BUREAU OF LAND MANAGEMENT BUREAU OF LAND MANAGEMENT SUNDRY NOTICES AND REPORTS OF WALLS BAD FIELD CHARGE See Attached

Decision & Corrective Action for the Rigel 20 Fed Com 1H Battery in Response to NOWO #18MB019I, #18MB058I, #18MB059I, 18MB060I, 18MB061I & AMENDMENT TO THE APPROVED CTB/OLM, SALES, & STORAGE APPROVED ON 01/10/2015

Federal Lease: NMNM0557729 (12.5%) NMNM63362 (Schedule B) NMNM28328 (12.5%) NMNM129458 (CA)

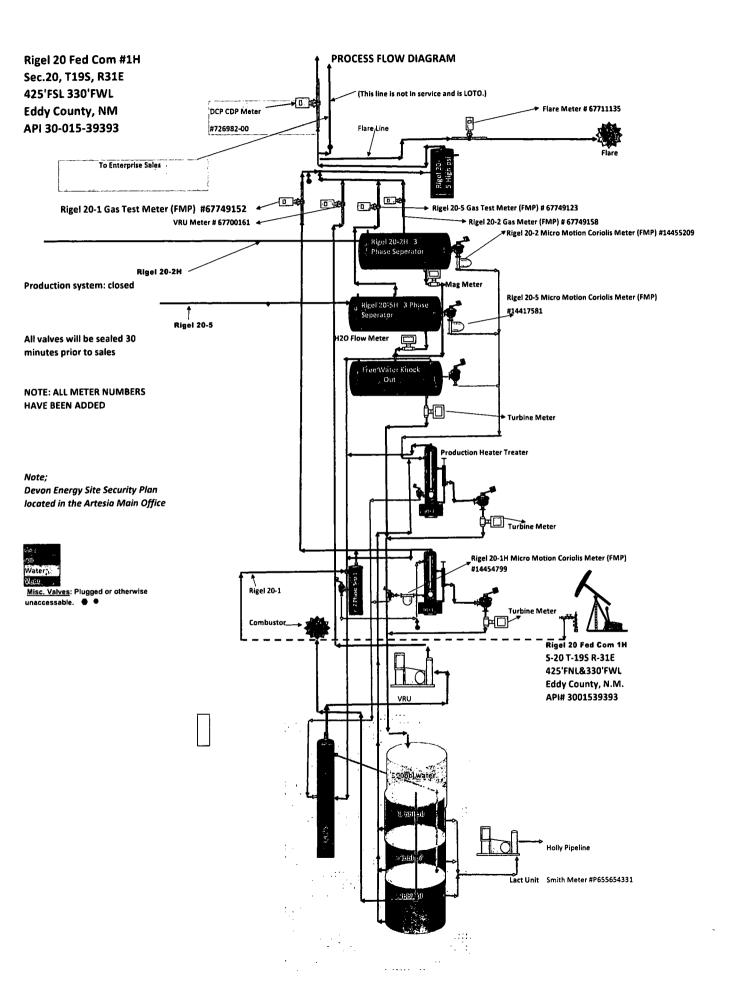
The Rigel 20 Fed Com 1H production flows into its own two phase separator (2PS-1). After separation, the gas flows to the gas test meter (FMP) #67749152. The produced fluids from the Rigel 20 FC 1H is then routed to its own heater/treater (HT-1) where oil is metered with a Micro Motion Coriolis Meter (FMP) #14454799 after flowing through its own heater/treater (HT-1). The produced water from the Rigel 20 FC 1H is metered utilizing mag meter off the heater/treater (HT-1), it then flows into the 500 bbl. water tank on site.

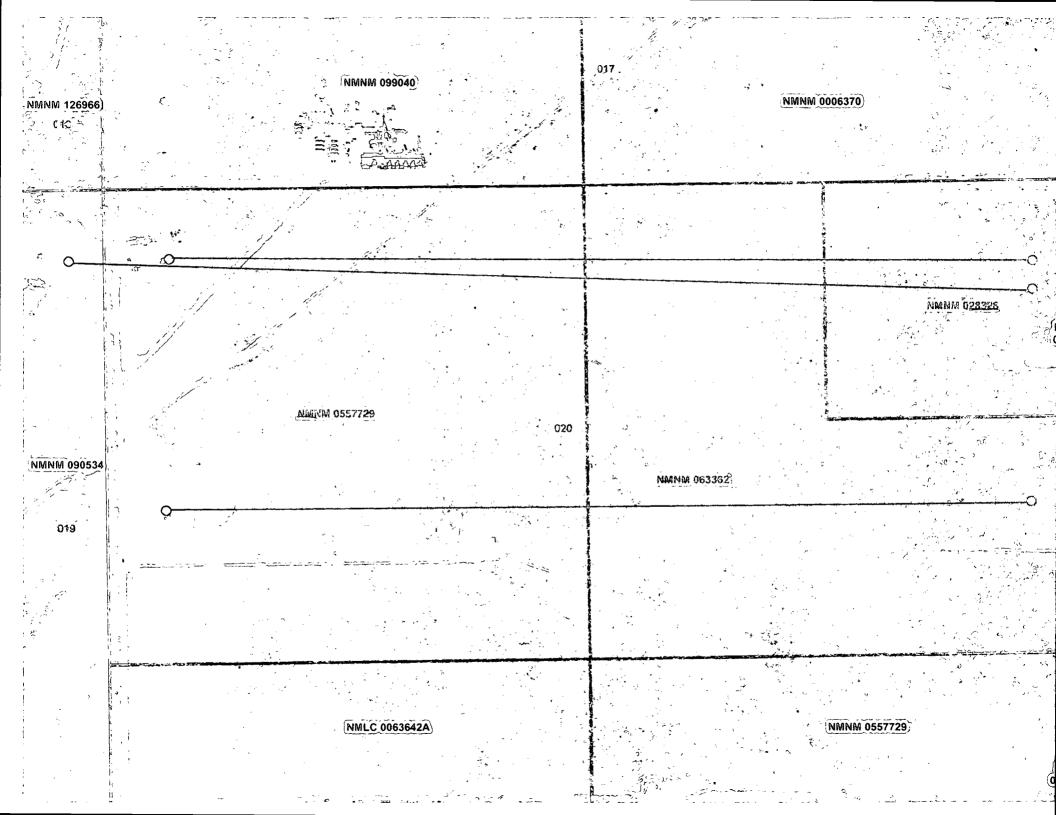
The Rigel 20 Fed Com 2H production flows into the Rigel 20 FC 1H facility directly from the 2H's production flow line from the well into its own 3 phase separator located at the Rigel 20 Fed Com 1H facility. Gas exits the 3 phase separator and is routed to the gas test meter (FMP) #67749158. The produced oil exits the 3 phase separator and is metered with a Micro Motion Coriolis Meter (FMP) #14455209 and then flows into the heater/treater (HT-2). The produced water from the Rigel 20 FC 2H is metered utilizing a mag meter off the three phase separator. Produced water then flows into the FWKO and out to the 500 bbl. produced water tank on site.

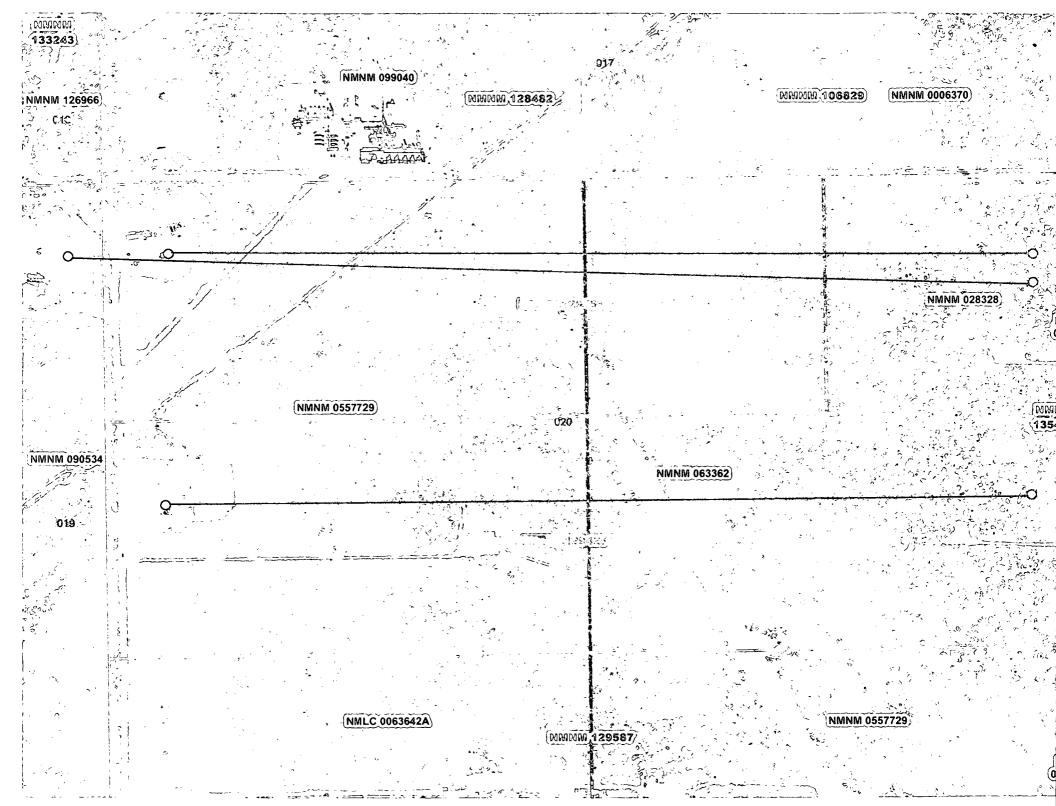
The Rigel 20 Fed Com 5H production flows into the Rigel 20 FC 1H facility directly from the 5H's production flow line from the well into its own 3 phase separator located at the Rigel 20 FC 1H facility. Gas exits the 3 phase separator and is routed to the gas test meter (FMP) #67749123. The produced oil exits the 3 phase separator and is metered with a Micro Motion Coriolis Meter

(FMP) #14417581 and then flows into the heater/treater (HT-2). The produced water from the Rigel 20 FC 5H is metered utilizing a mag meter off of the 3 phase separator. Produced water then flows into the FWKO and out to the 500 bbl. produced water tank on site.
